Planning Commission Meeting

Wednesday, January 22, 2025 at 6:00 PM

MEETING DATE:	January 22, 2025
PROJECT:	CVS (Store 2745) at May River Crossing - Certificate of Appropriateness-Highway Corridor Overlay District (HCO)
PROJECT MANAGER:	Charlotte Moore, AICP Principal Planner

MEETING DATE:	January 22, 2025
PROJECT:	Culver's Bluffton Preliminary Development Plan
APPLICANT:	William Heintz, Kimley-Horn
PROJECT NUMBER:	DP-10-24-019406
PROJECT MANAGER:	Dan Frazier Planning Manager Department of Growth Management

FRONT SIDE ELEVATION

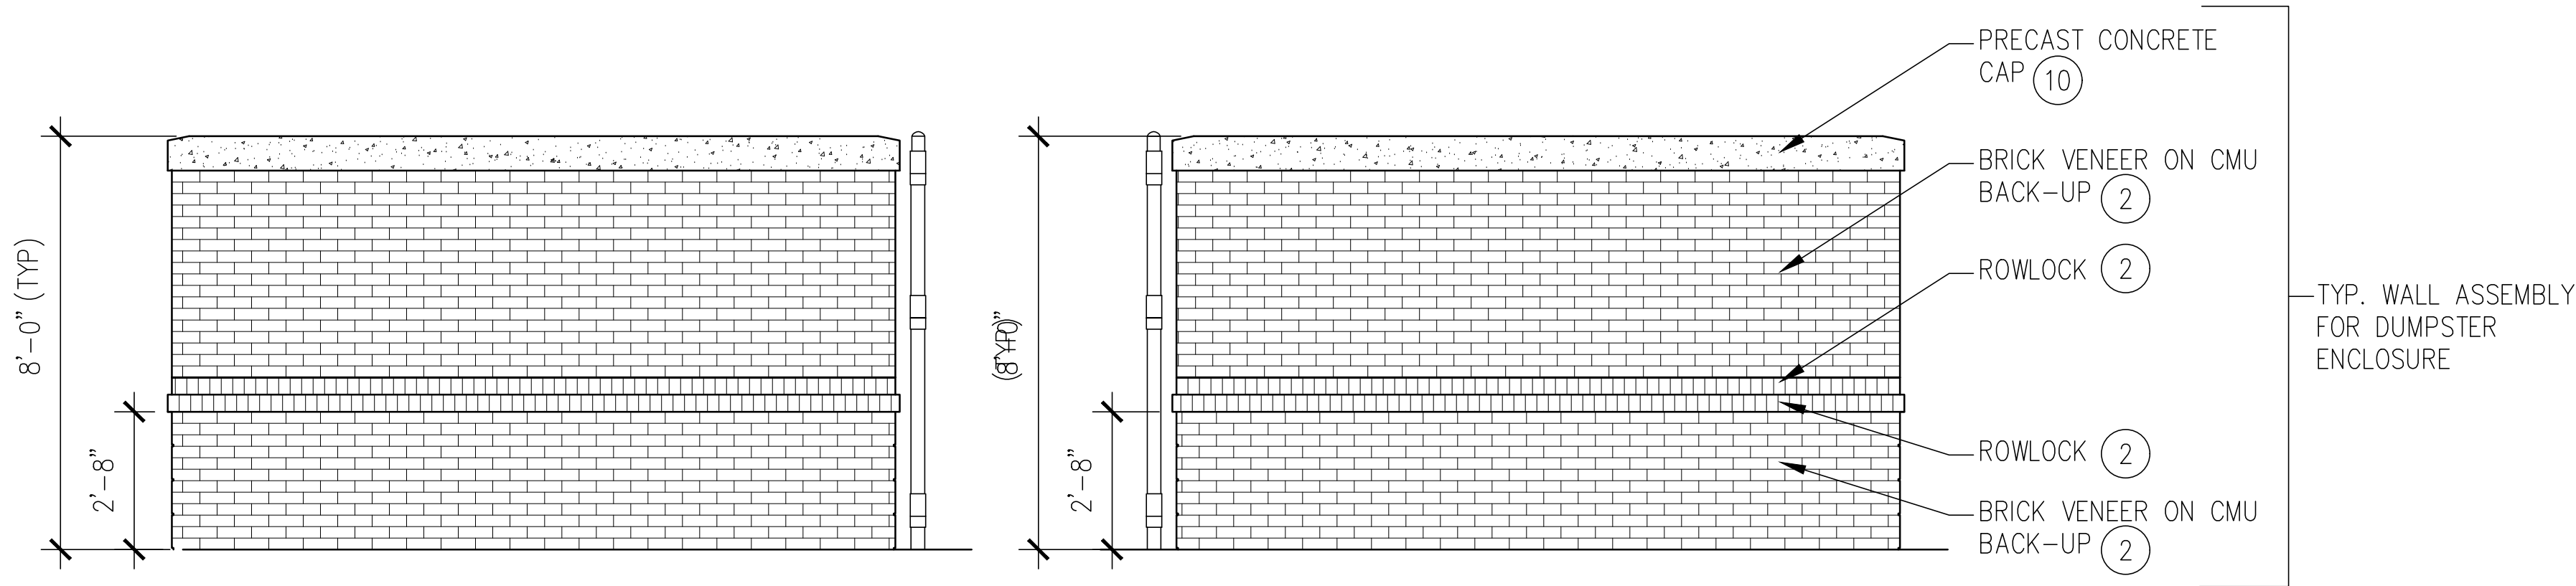
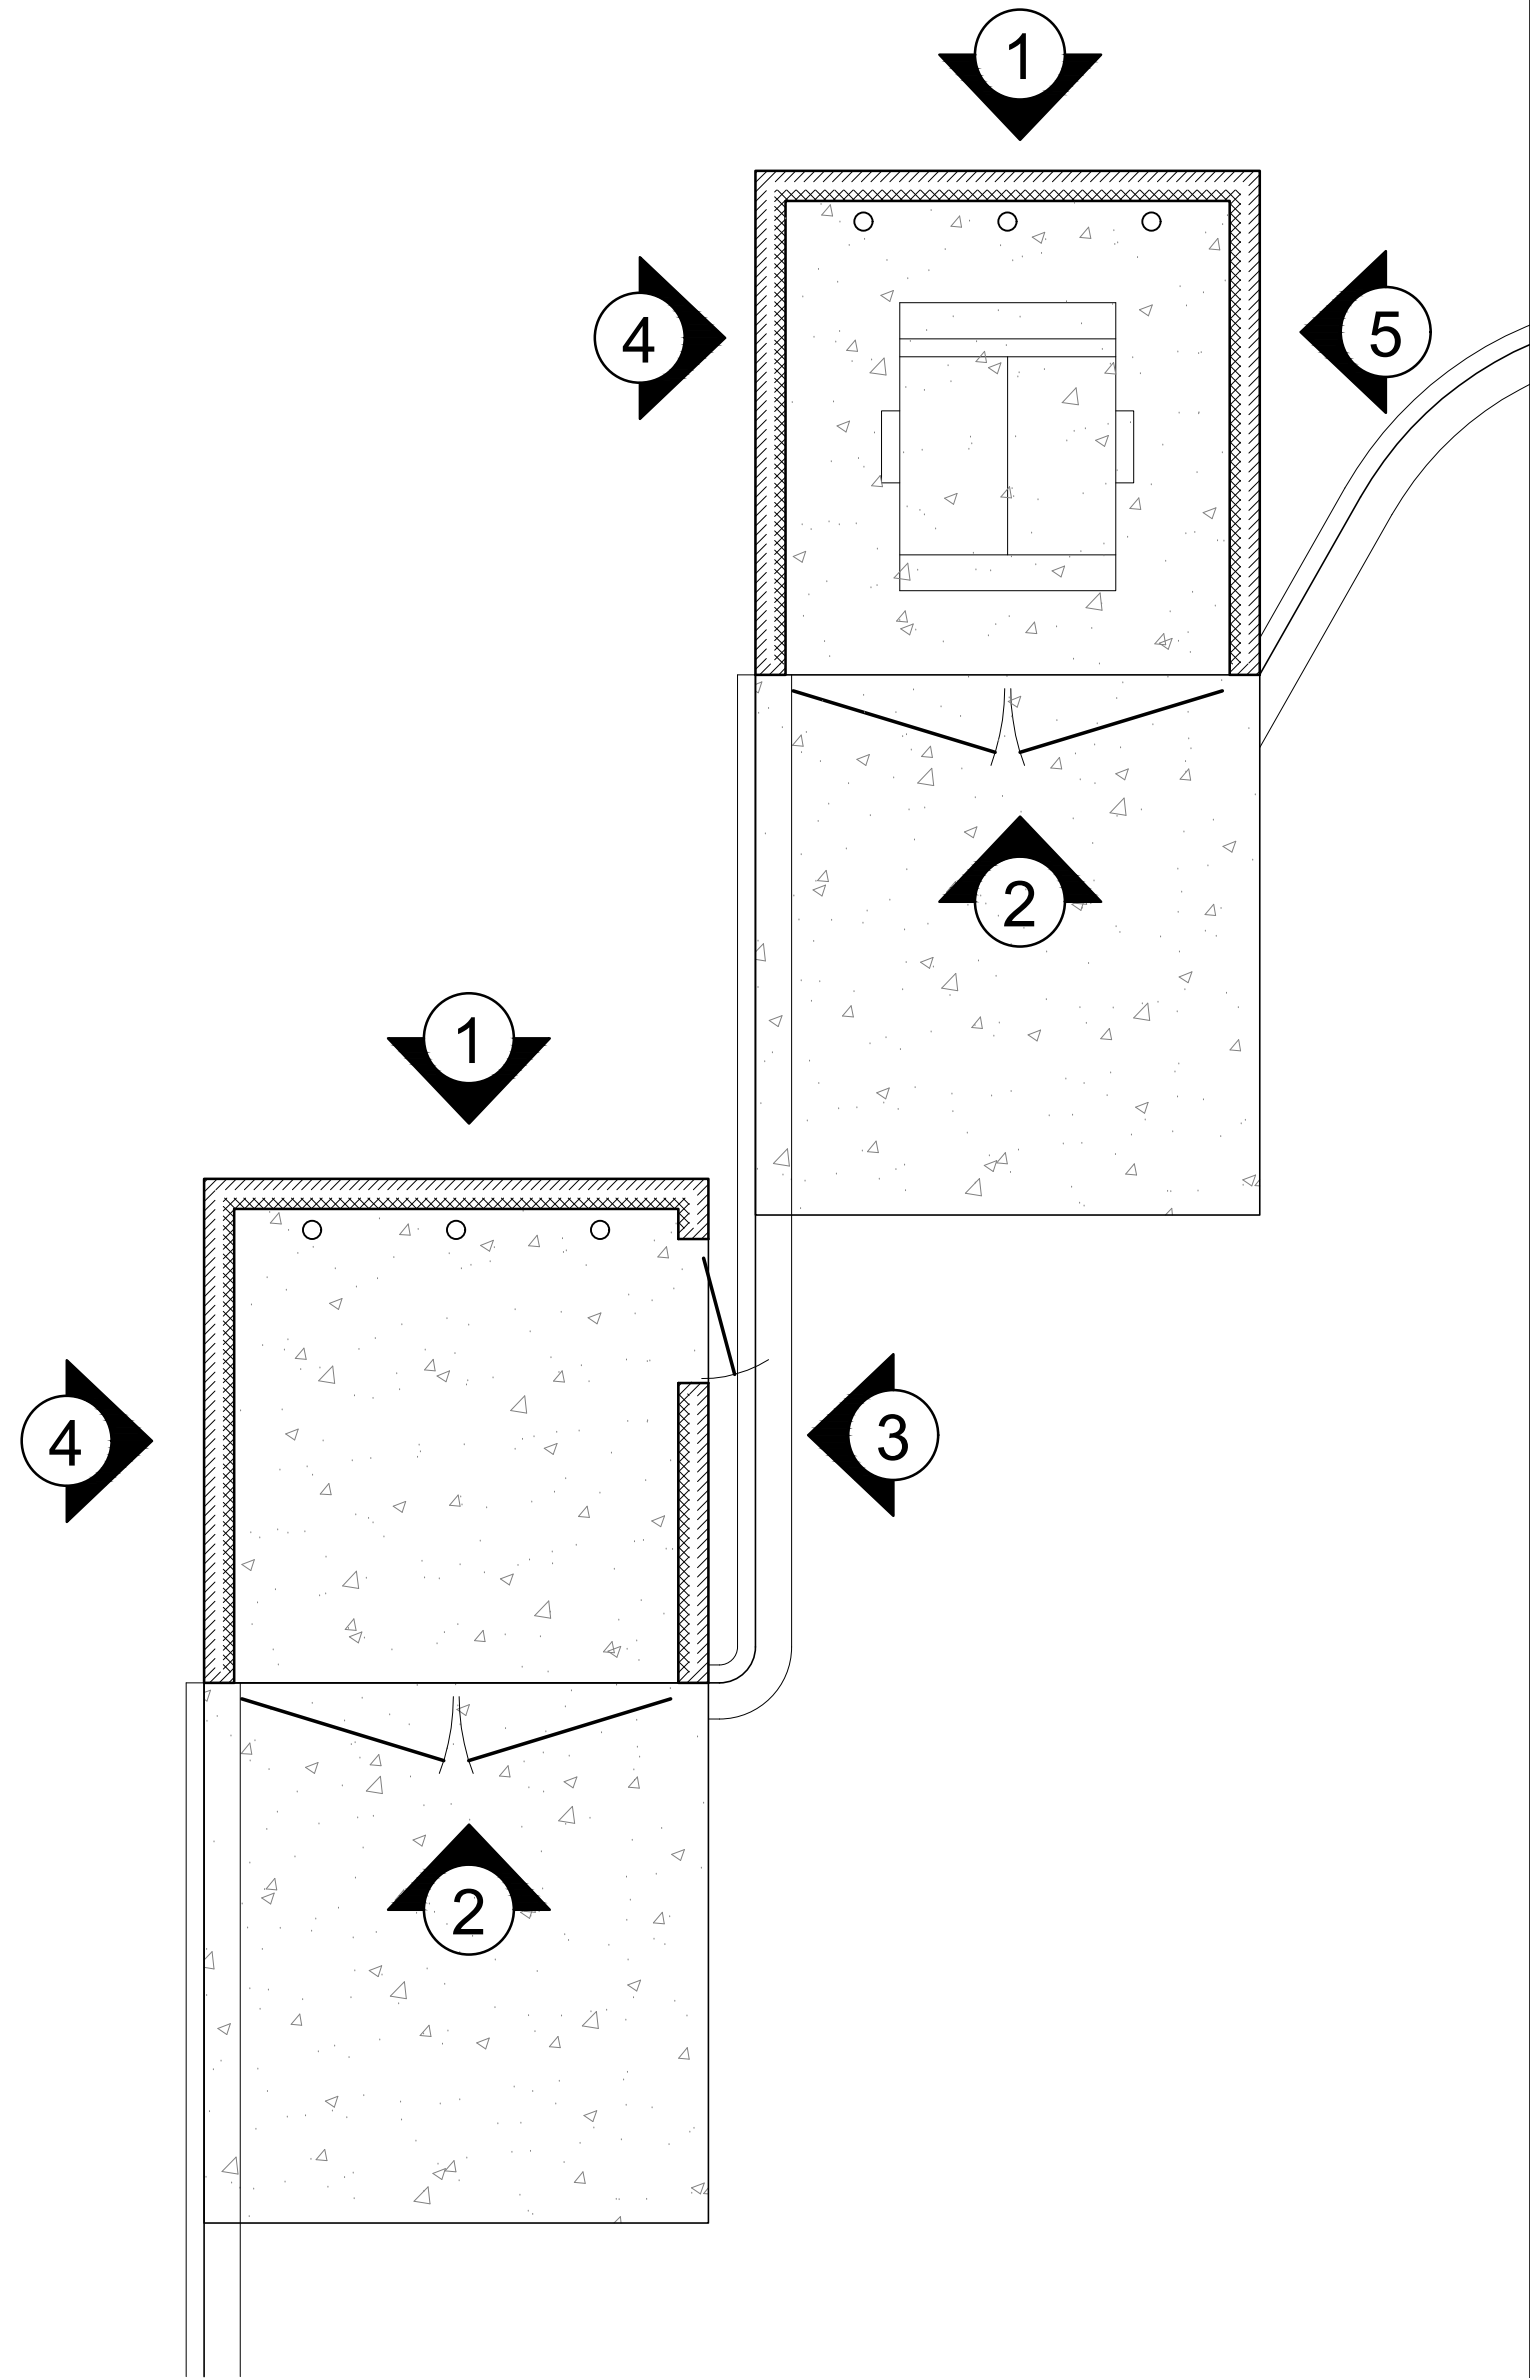
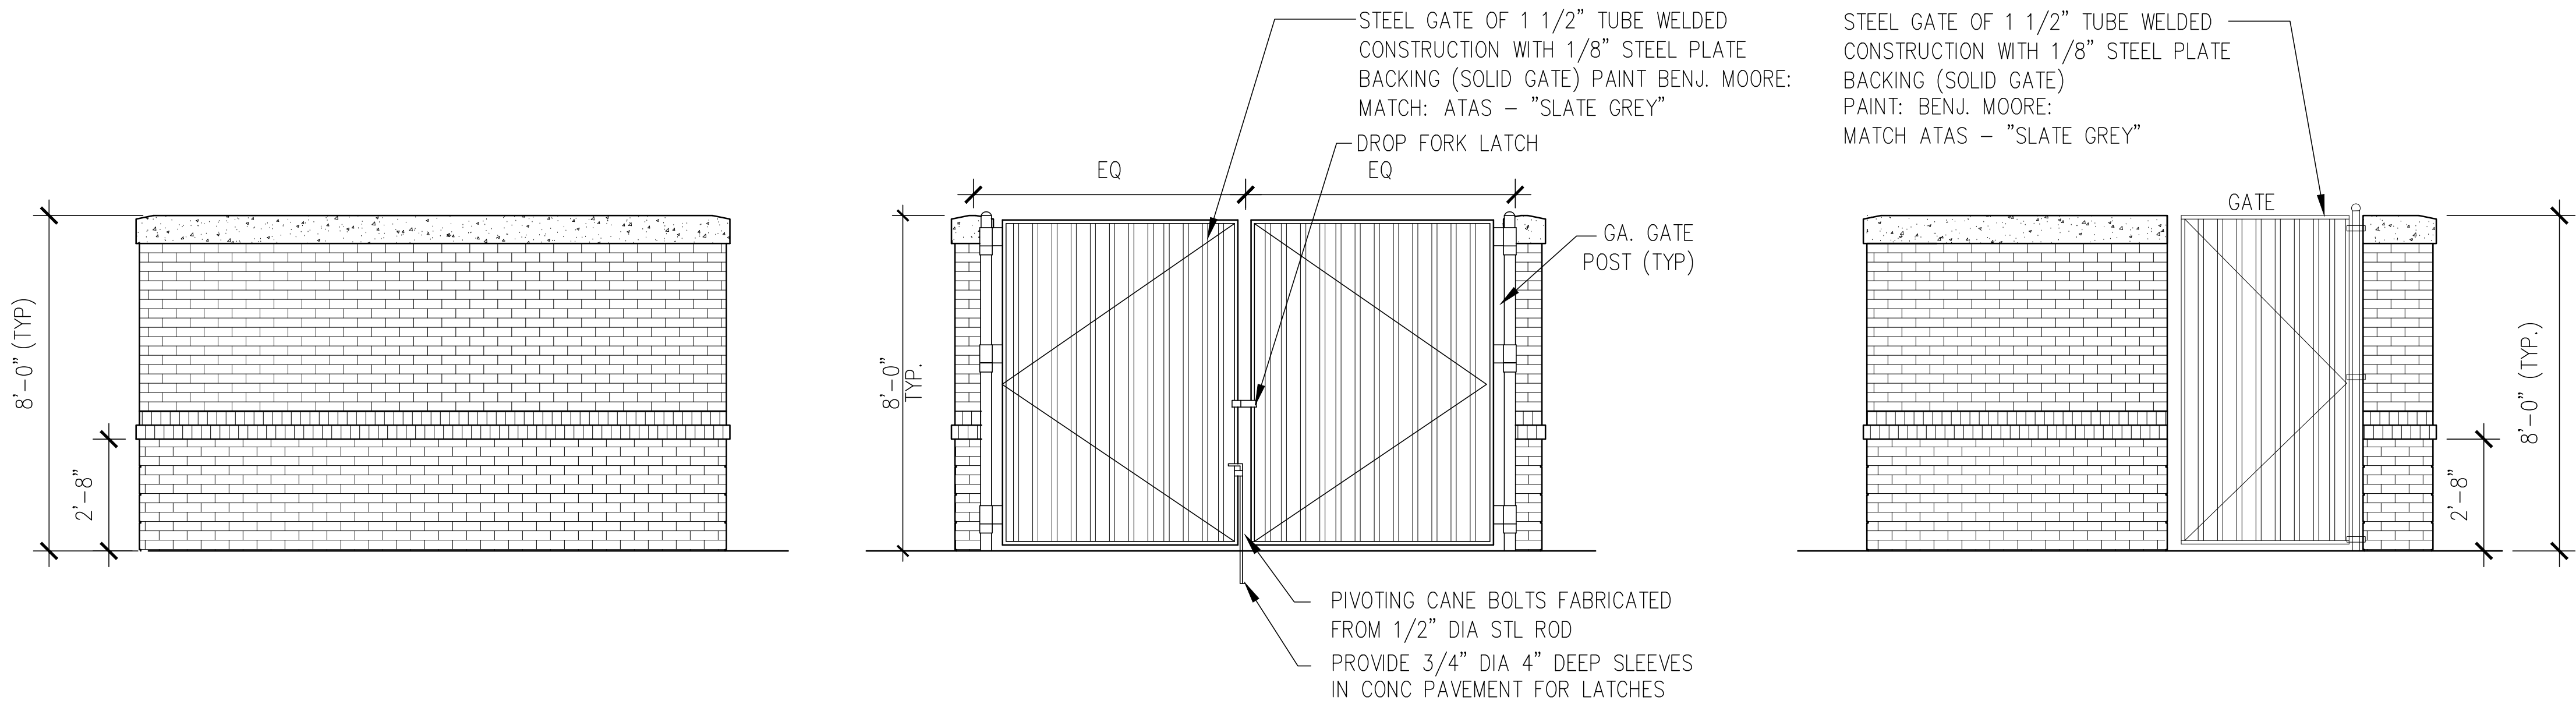
- b. **Finding- Accent Colors.** Black is the proposed color for parapet coping, decorative shutters, and window mullions. Sec. 5.15.9.(D)(5) allows black to be used as an accent color on a limited basis and at the discretion of the Planning Commission. Of particular concern is the use of a black parapet coping as the contrast against lighter colors appears to emphasize the lack of roofline variation.

- e. **Finding – Brick Base.** As the building is proposed to be 25 feet tall (approximately two stories), the brick base should be higher to provide the appearance of a more substantial foundation and to provide more visual interest.

- a. See response to item #1, above.
3. *As the site is located on three roads (Hwy 170, Evan Way and May River Crossing), architectural treatment of these facades must be elevated beyond what has been provided. Hwy 170 and May River Crossing can be treated as secondary frontages and, therefore, should have at least 50% of a shopfront appearance. Long, unarticulated or blank facades are not permitted but are indicated on the Hwy 170 elevation (“Rear”) and the southern elevation (“Right Side”). The rear elevation is the southern elevation (identified as “Right Side”). Service areas, including doors, must be in the rear of the building, as should any electrical panels. Sec. 5.15.9.E. (3)*

- a. All facades have been revised to incorporate additional design features, façade articulation, and variation of cladding color, pattern and texture.

- a. Proposed building colors have been revised to compliment a light grey palette, utilizing darker accent colors of charcoal (metal awnings) and matte black (coping, window mullions and decorative shutters) to create a balanced color assemble. The weathered brick tone color provides a touch of warmth to soften the overall palette.
